PROPOSAL, CONTRACT, BOND AND SPECIFICATIONS

PHEASANT BRANCH GREENWAY ENHANCEMENT

CONTRACT NO. 9517

14370  
 P21

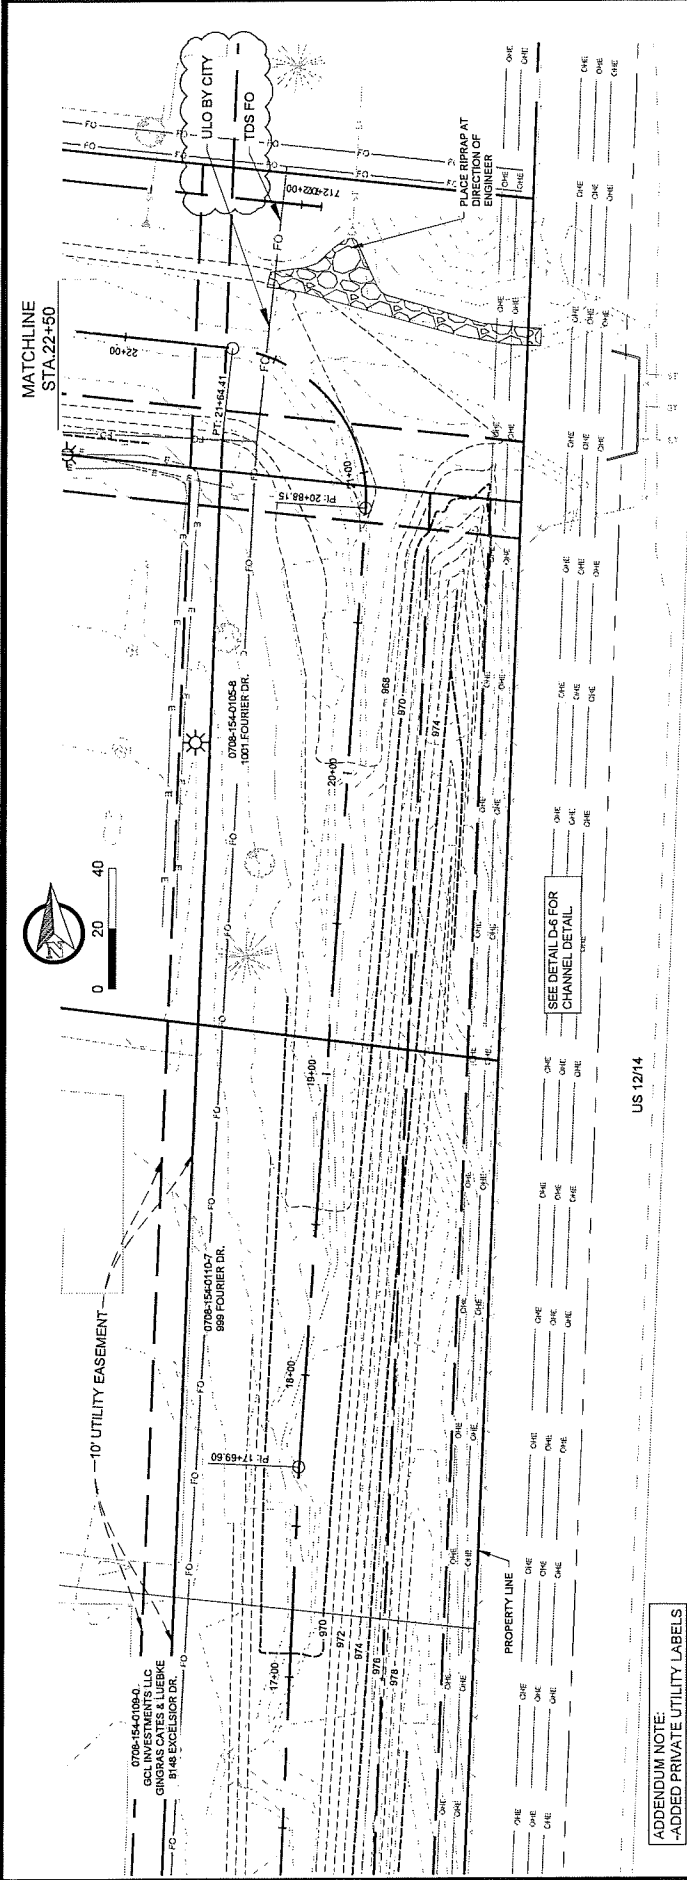
APPENDUM NOTE:  
 -ADDED PRIVATE UTILITY LABELS

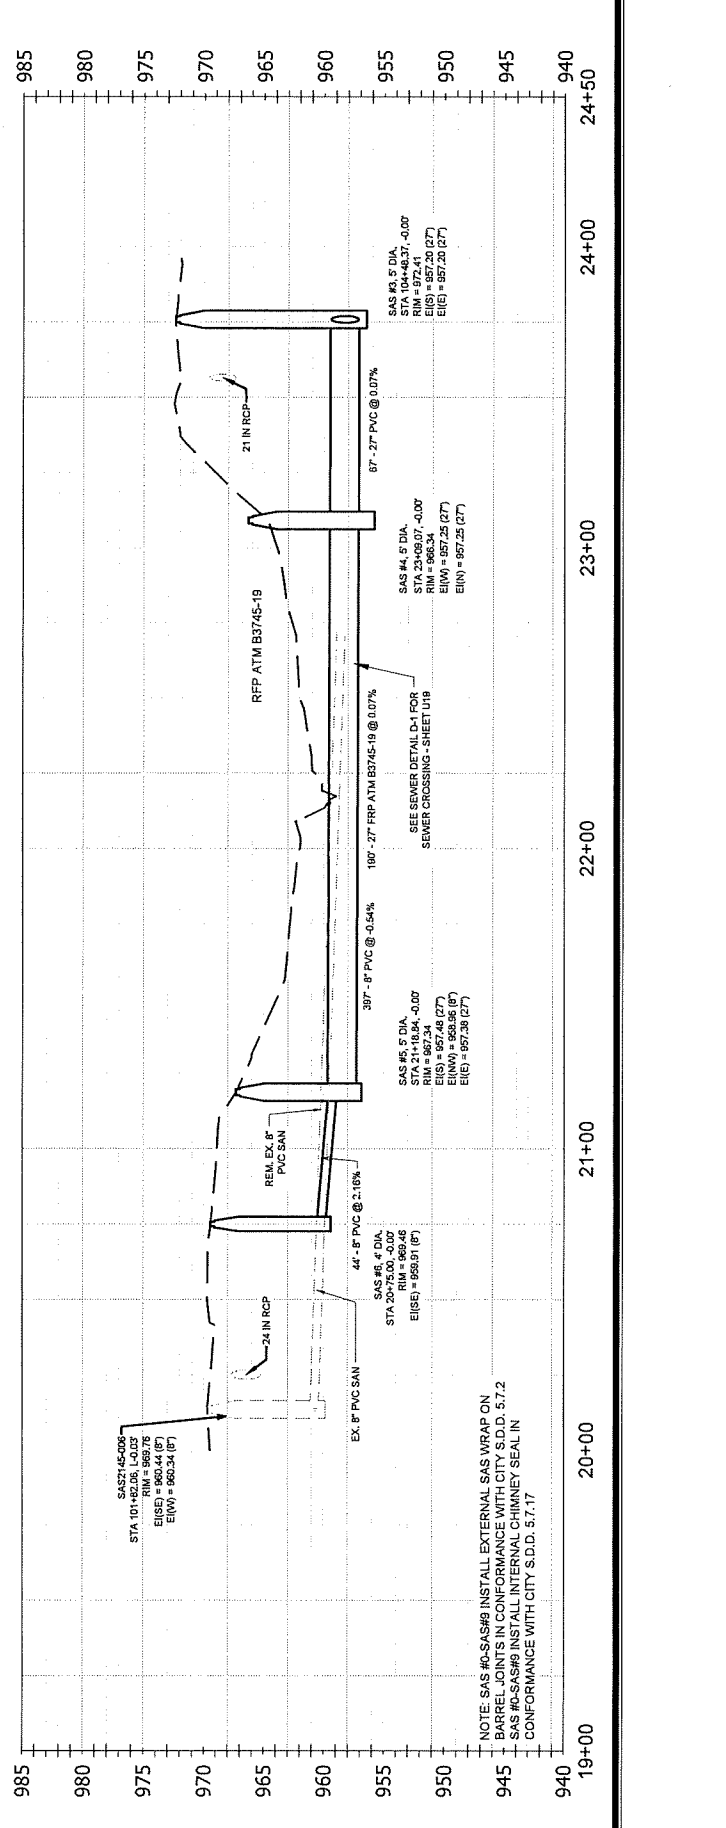
**ADDENDUM NOTE:**  
 -REVISED UTILITY LABELS  
 -UPDATED BID ITEM NUMBER  
 -UPDATE LEGEND

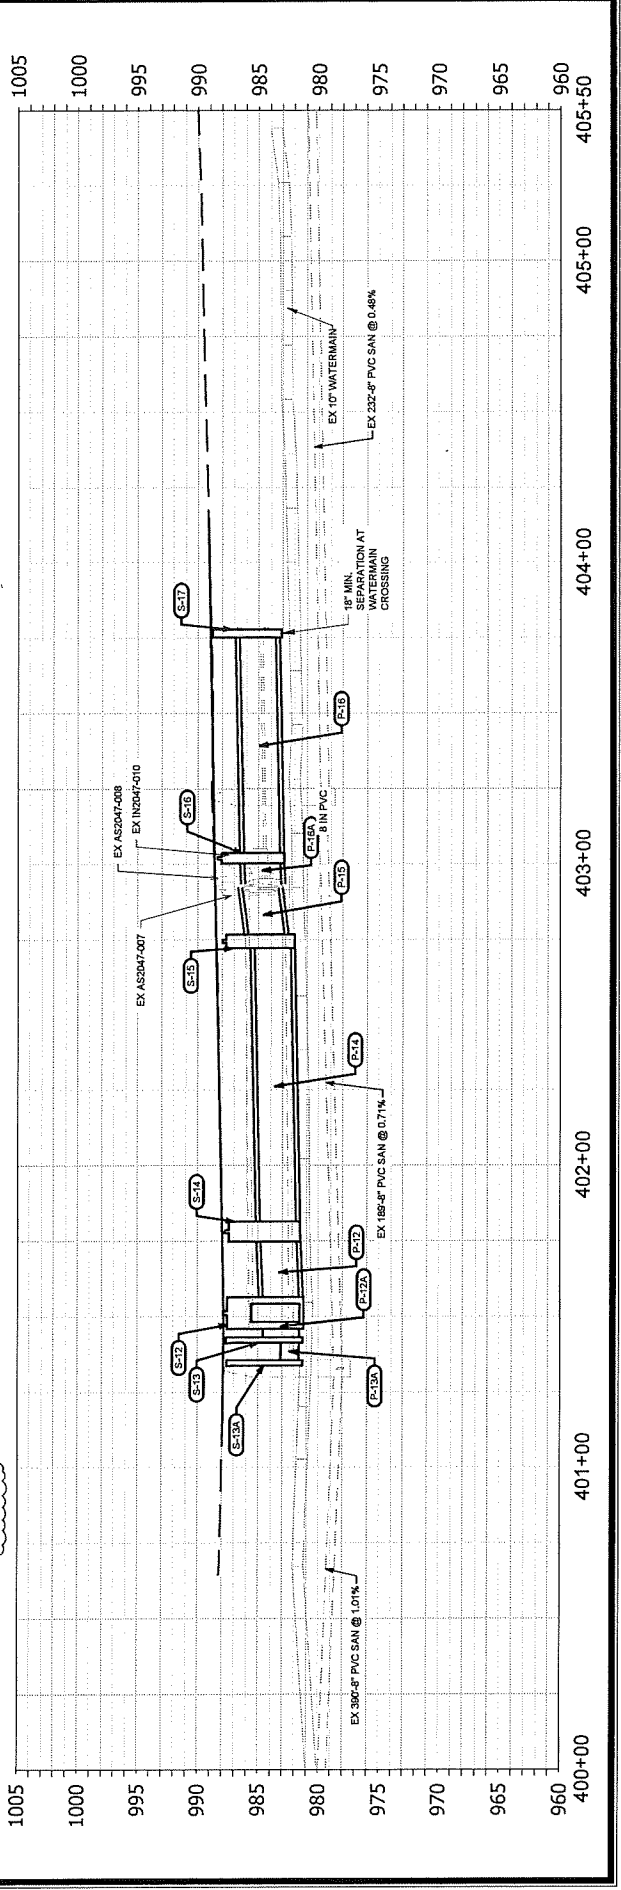
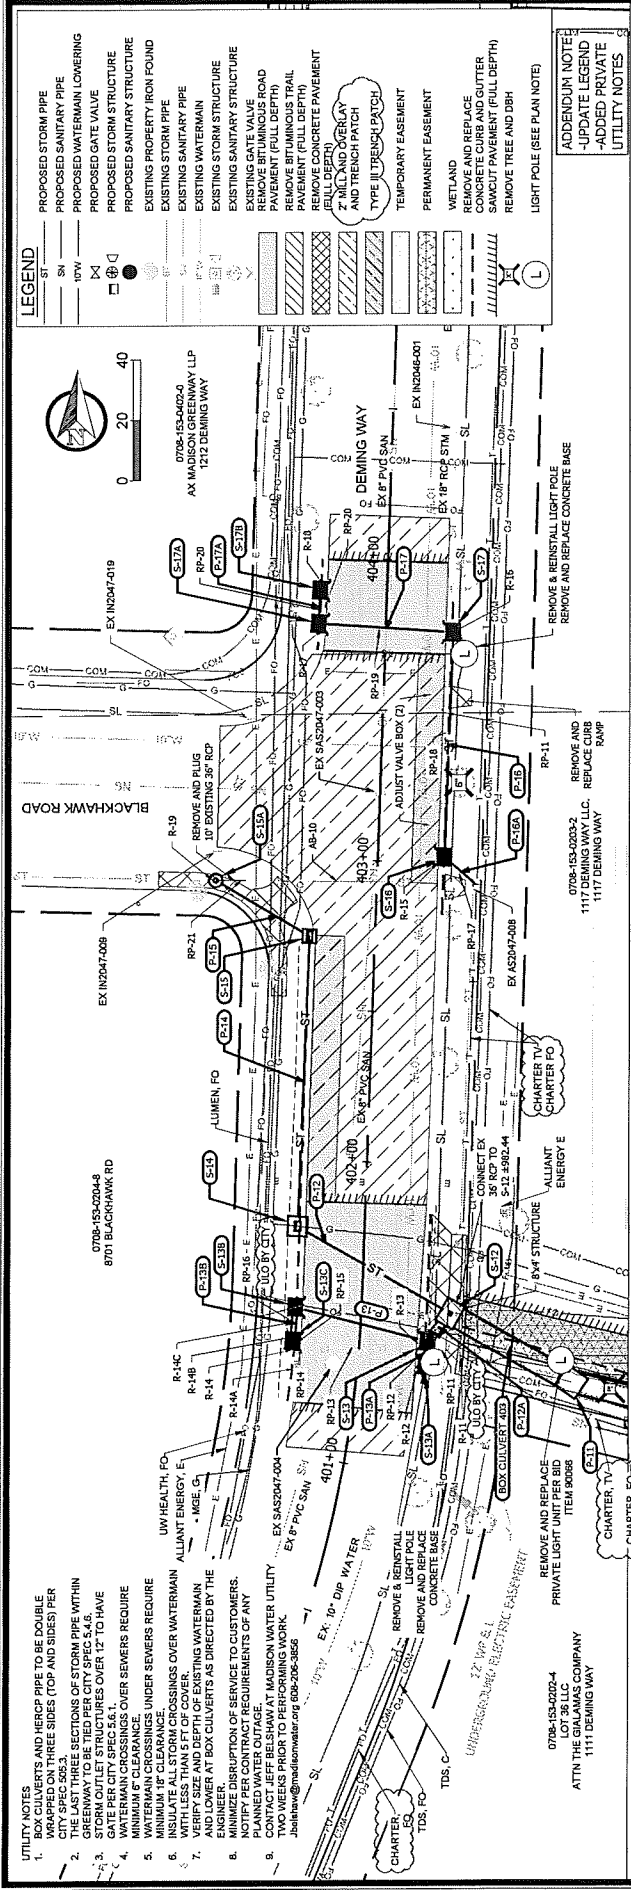
**APPENDIX NOTE:**  
 -REVISED UTILITY LABELS  
 -UPDATE LEGEND

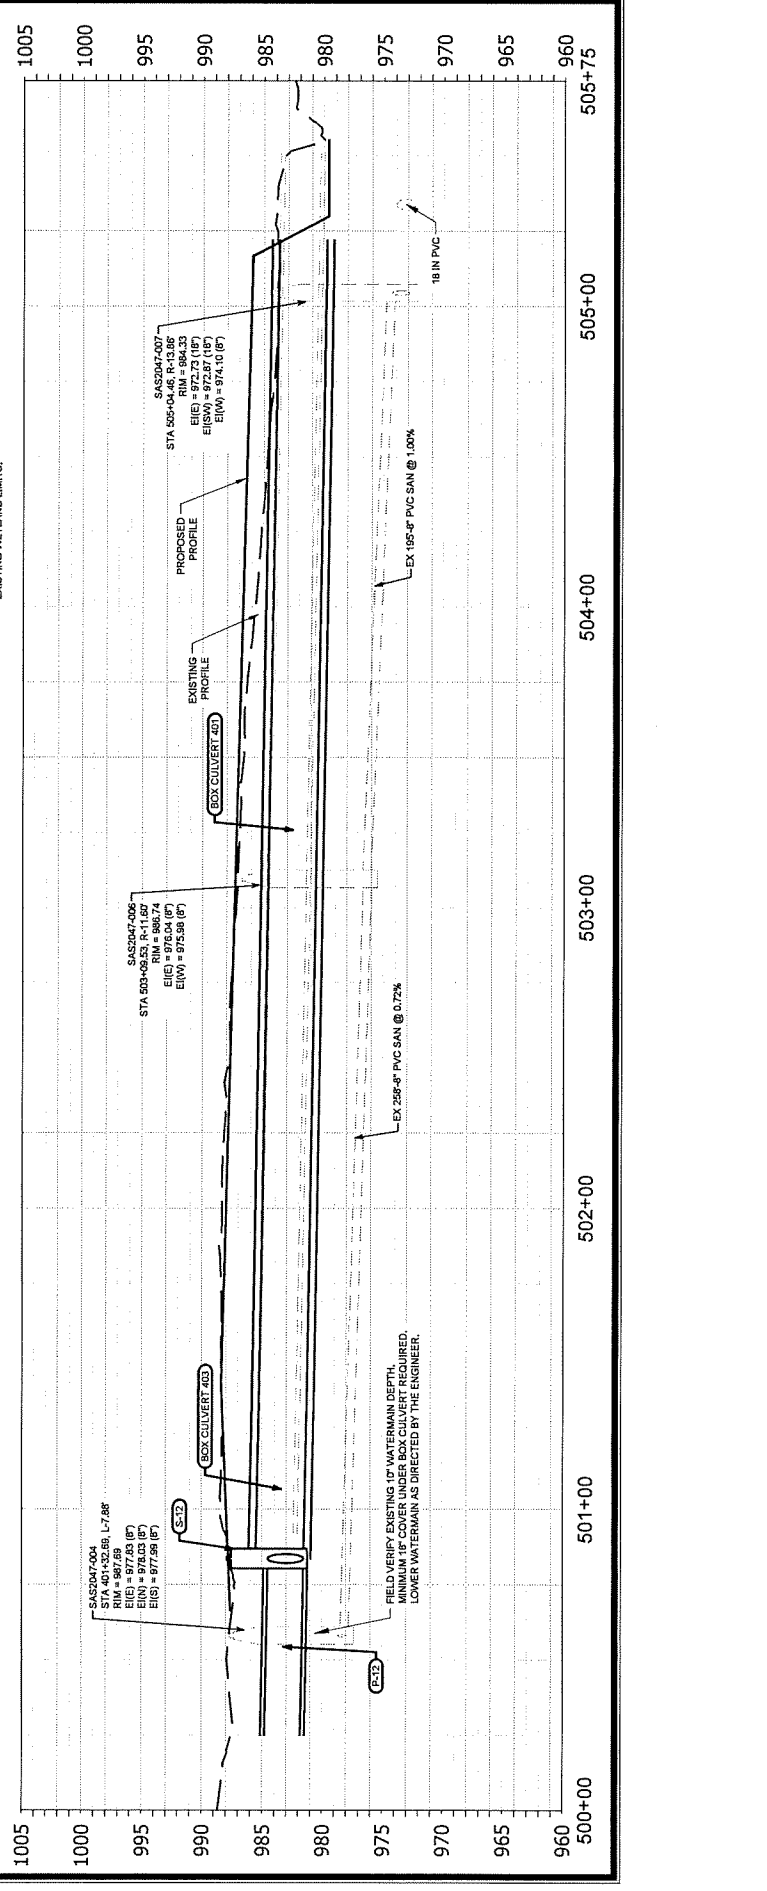
**ADDENDUM NOTE:**  
 -UPDATE LEGEND  
 -ADDED PRIVATE UTILITY NOTES

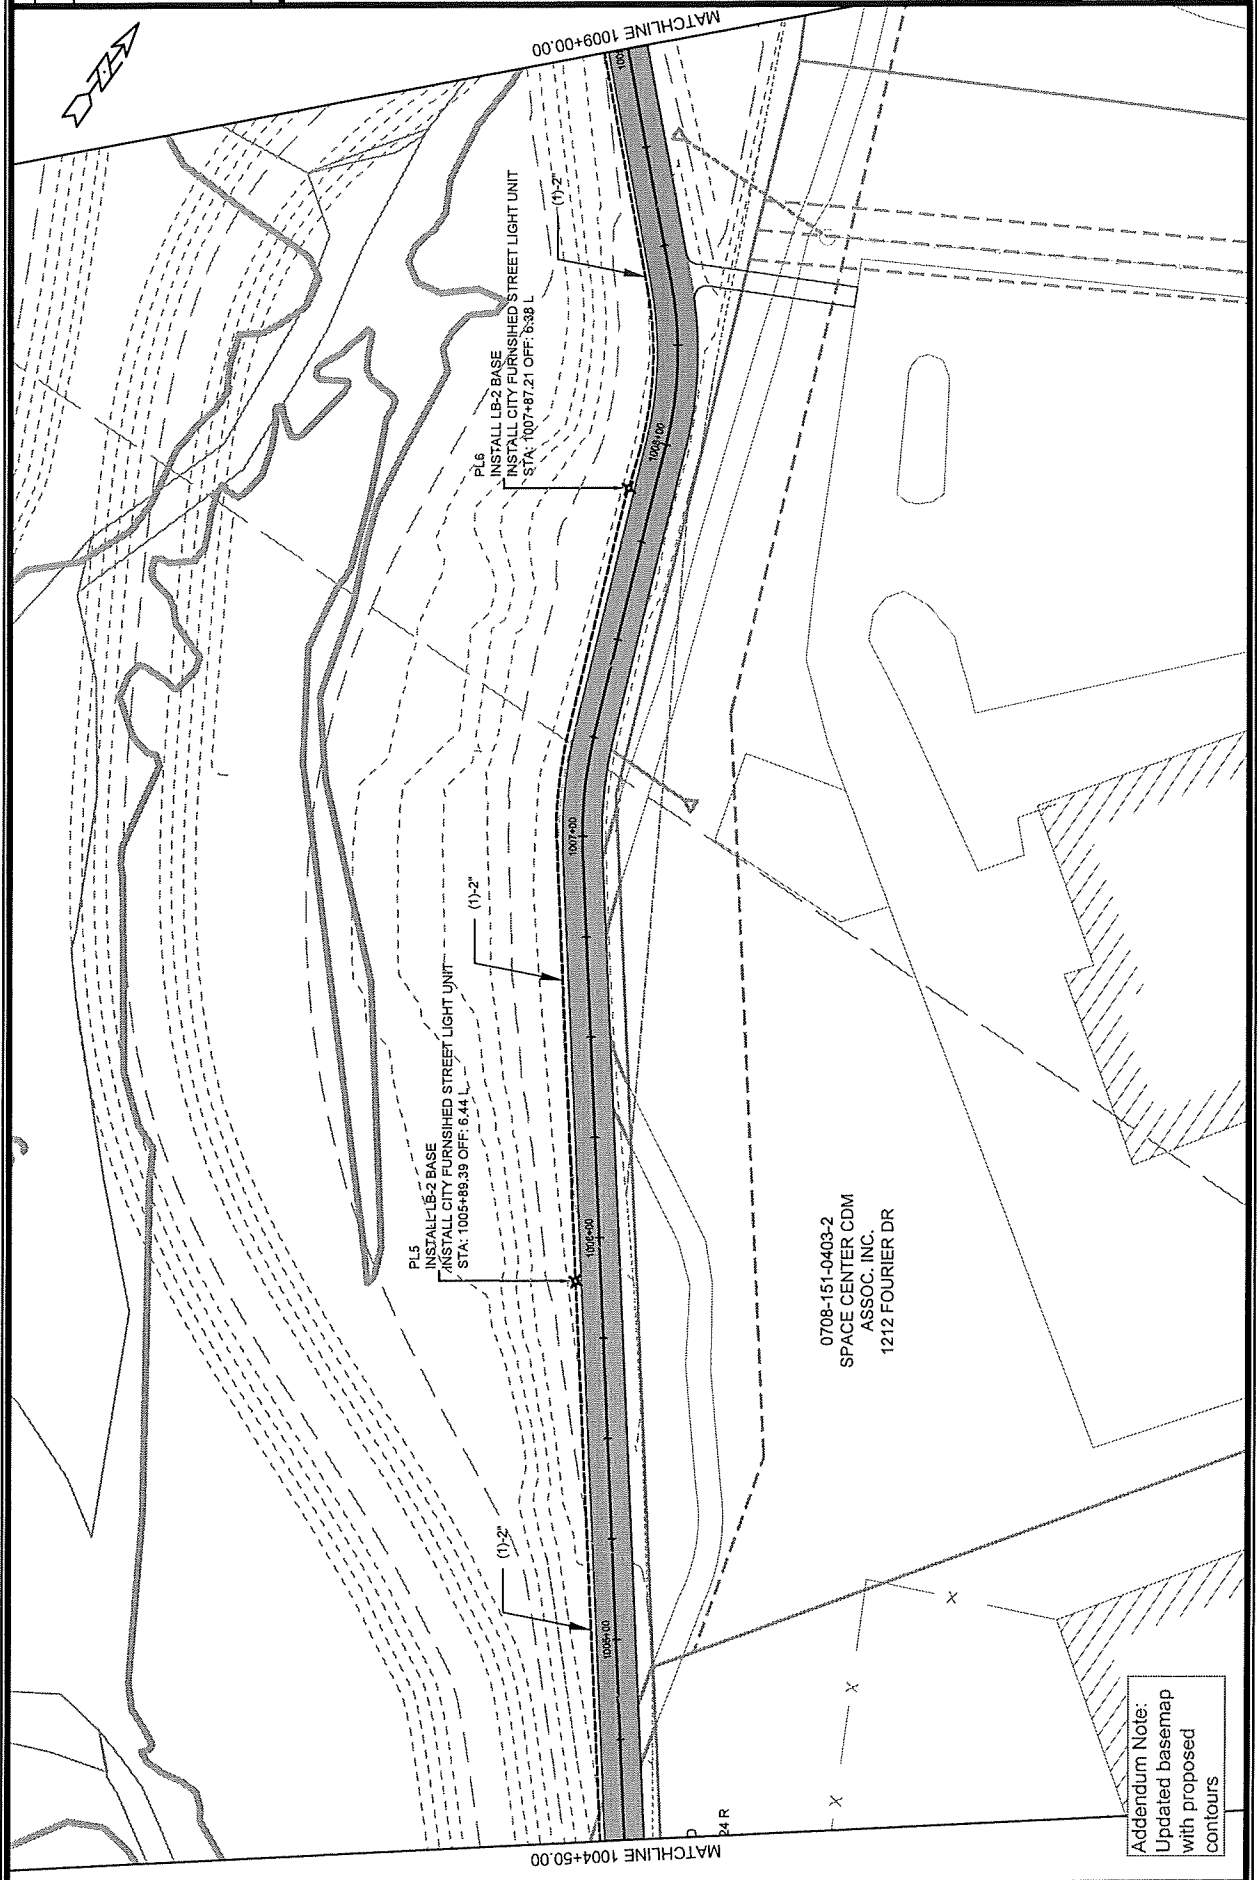
Addendum Note:  
 Updated basemap  
 with proposed  
 contours

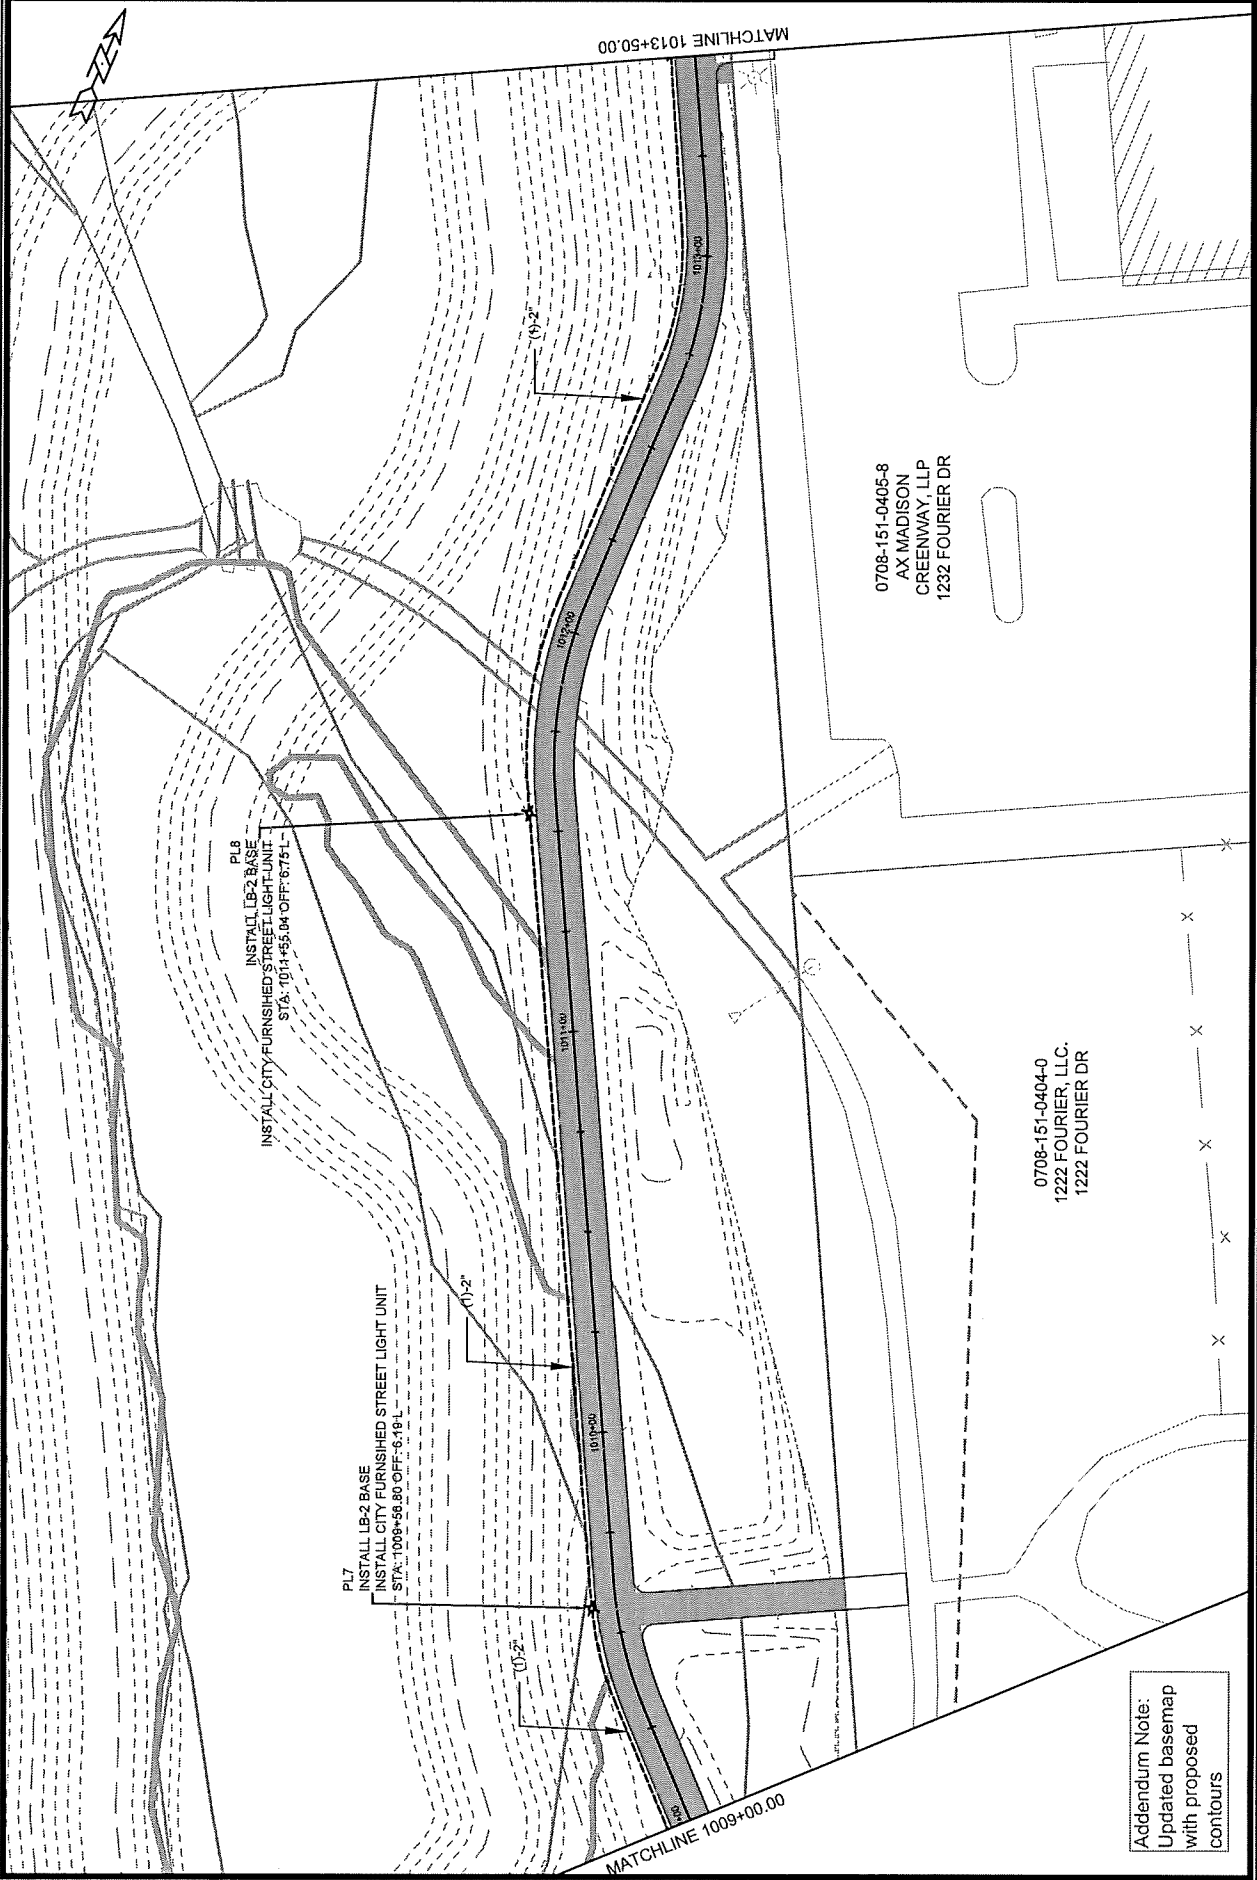
Addendum Note:  
Updated basemap  
with proposed  
contours
